V2500-A1/A5/D5 PROPULSION SYSTEMS SERVICE BULLETIN

This document transmits Revision 2 to Service Bulletin EV2500-72-0416 and Revision 1 to the Supplement

Bulletin Revision 2

ENGINE – ACTUATING MECHANISM HP COMPRESSOR VARIABLE VANES – INTRODUCTION OF REVISED
BRIDGE PIECE ASSEMBLIES AND UNISON RING ASSEMBLIES WITH INCREASED DOWEL LOCATION

Post Modification assembly of VIGV unison rings and bridge pieces
Fig.7

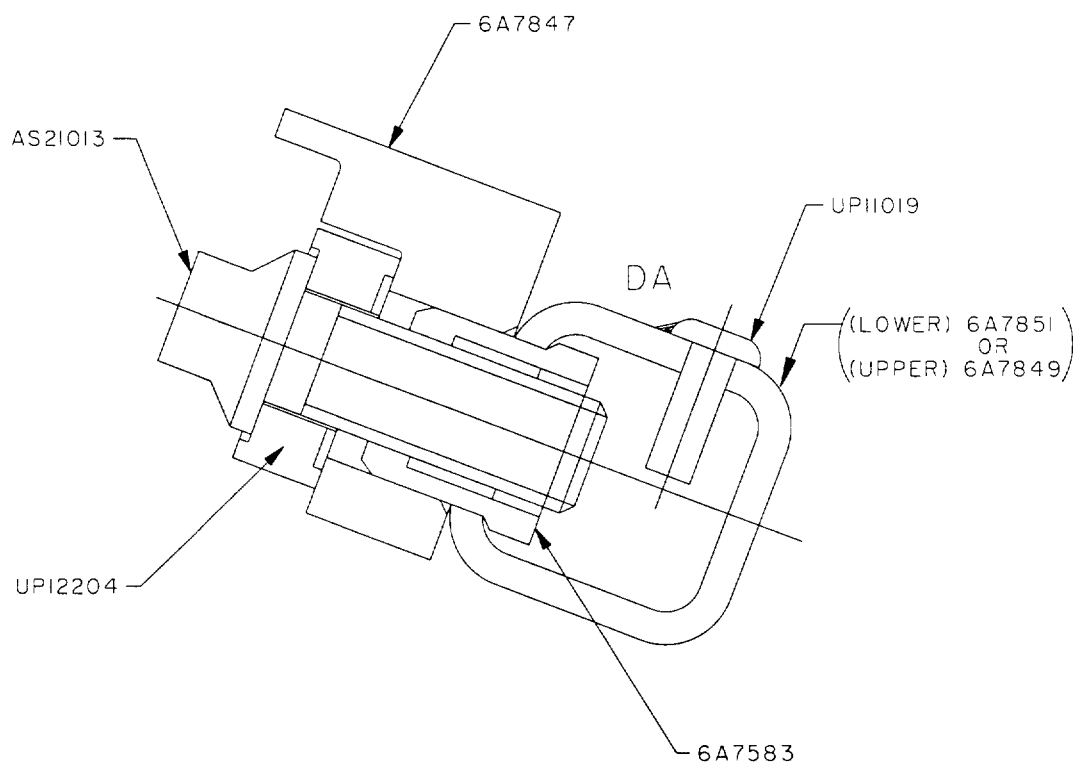
Remove	Incorporate	Reason for change
	Page 1 and 2 of the Summary	To add spacer to Material Information. To revise bolt part numbers on Figs 7 and 15. To revise brackets on Figs 18, 20, 27 and 29.
All pages of the Service Bulletin	Pages 1 to 81 of the Service Bulletin	To add spacer to Material Information. To revise bolt part numbers on Figs 7 and 15. To revise brackets on Figs 18, 20, 27 and 29.

To add spacer to Material Information. To revise bolt part numbers on Figs 7 and 15. To revise brackets on Figs 18, 20, 27 and 29.

Rework of Stage 4 unison rings and bridge pieces (Pre SB 72-0348 standard)
Fig.19

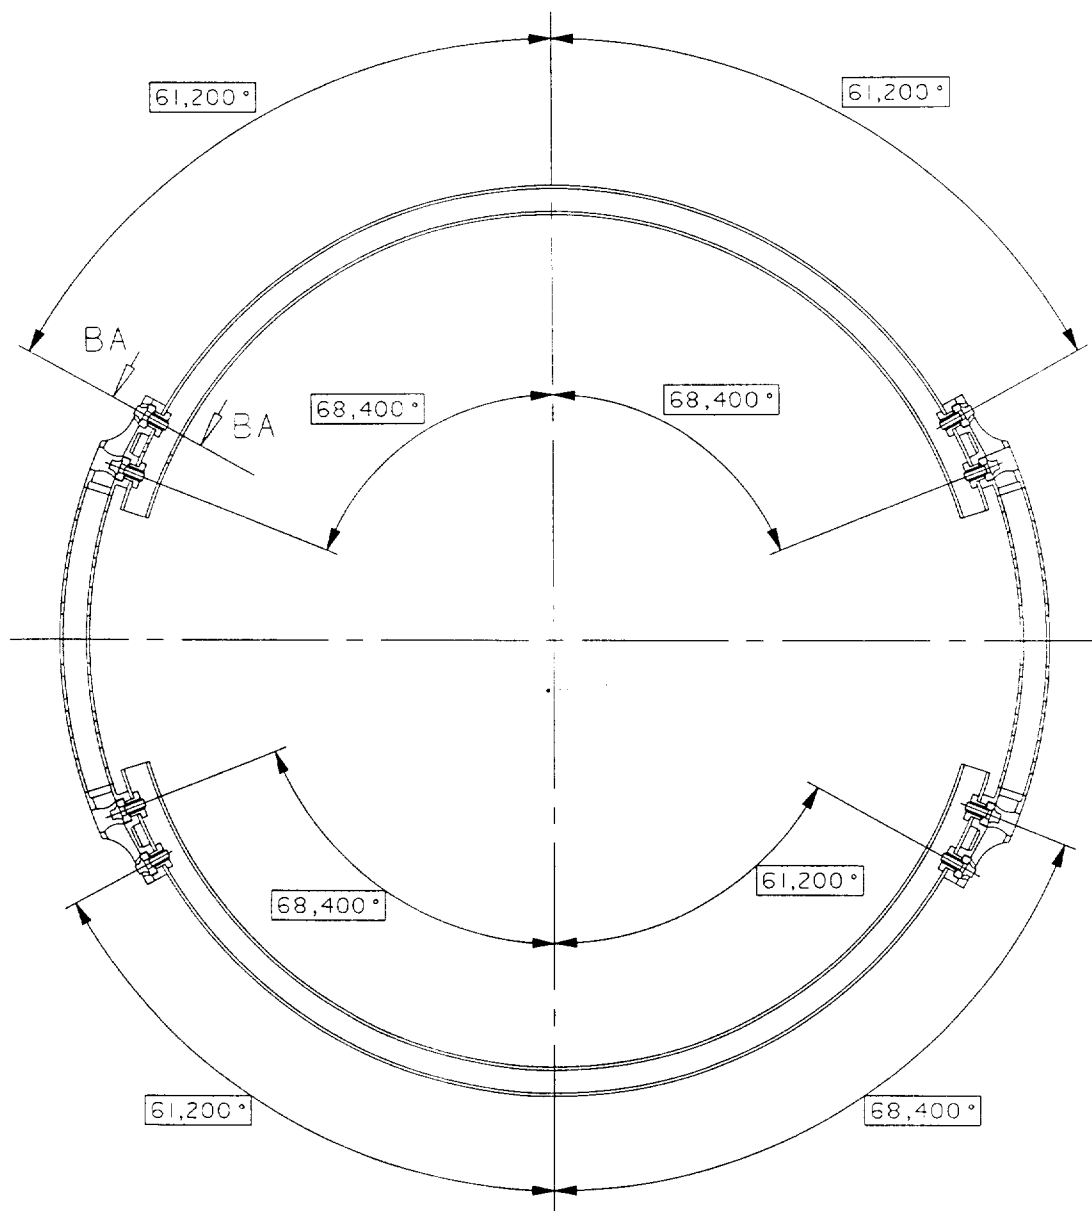
PROCEDURE	RELATED DATA
(a) Remove brackets and discard	See Figures 1, 18 and 20.
(b) Apply marking ink to the areas for rework	See Figures 19, 21 and 22. Use CoMat 02-124 marking ink. Use standard workshop equipment.

Rework of Stage 4 bridge pieces (SB 72-0348 standard)
Fig.25

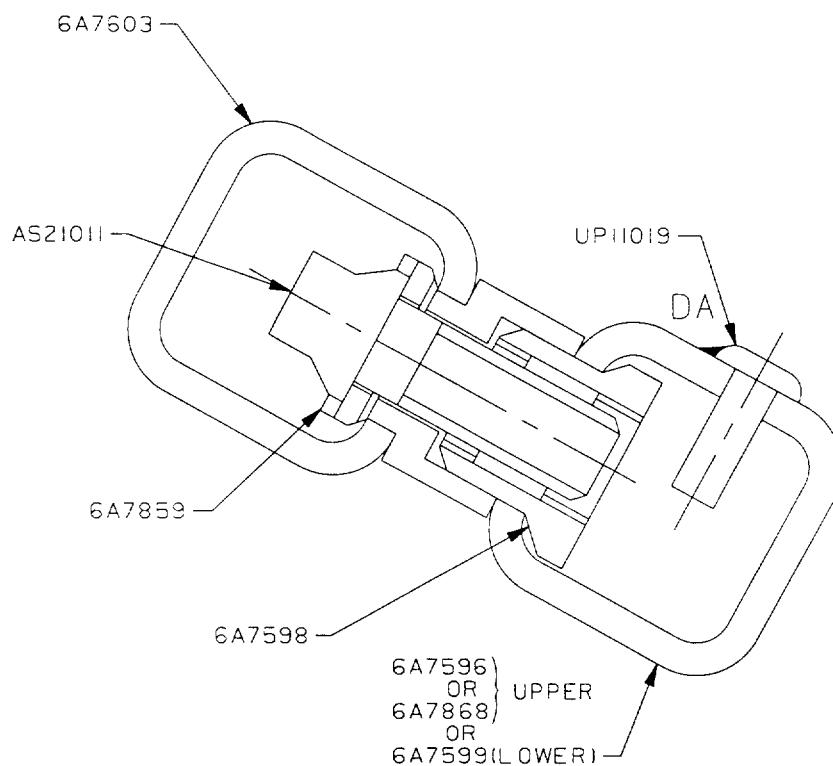
See Figure 25.
Use standard workshop equipment.

| (f) Install spacers | See Figure 25.

Rework of Stage 5 bridge pieces (SB 72-0348 standard)
Fig.34

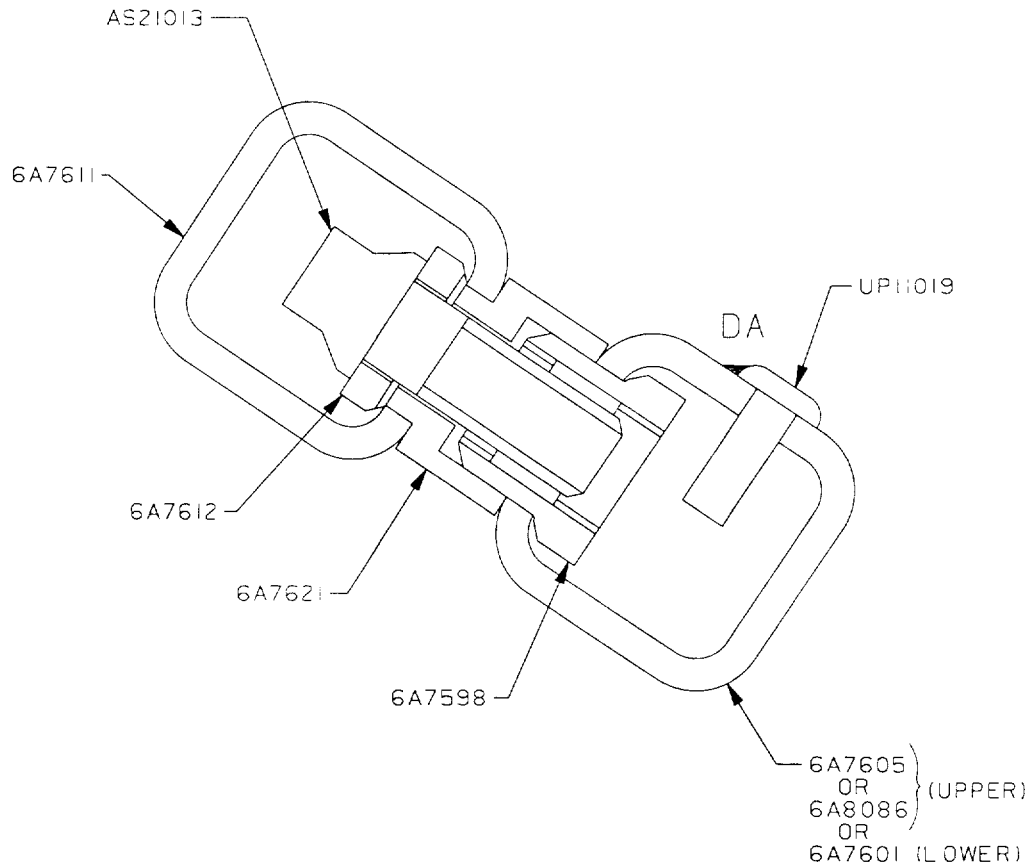
(a) Remove bridge piece end (4 positions)	See Figures 30 and 34. Use portable grinding equipment. A witness of weld on the bridge piece is permissible.
(b) Remove burrs	See Figure 34. Use standard workshop equipment.
(c) Remove spacers (8 off)	
(d) Do a local penetrant crack test of the reworked areas	Refer to SPM TASK 70-23-05-230-501. Use CoMat 06-022 fluorescent penetrant with penetrant crack test equipment. Cracks are not permitted.
(e) Visually examine and measure the dimensions of the reworked areas	See Figures 30 and 34. Use workshop inspection equipment.

| (f) Install spacers | See Figure 34.
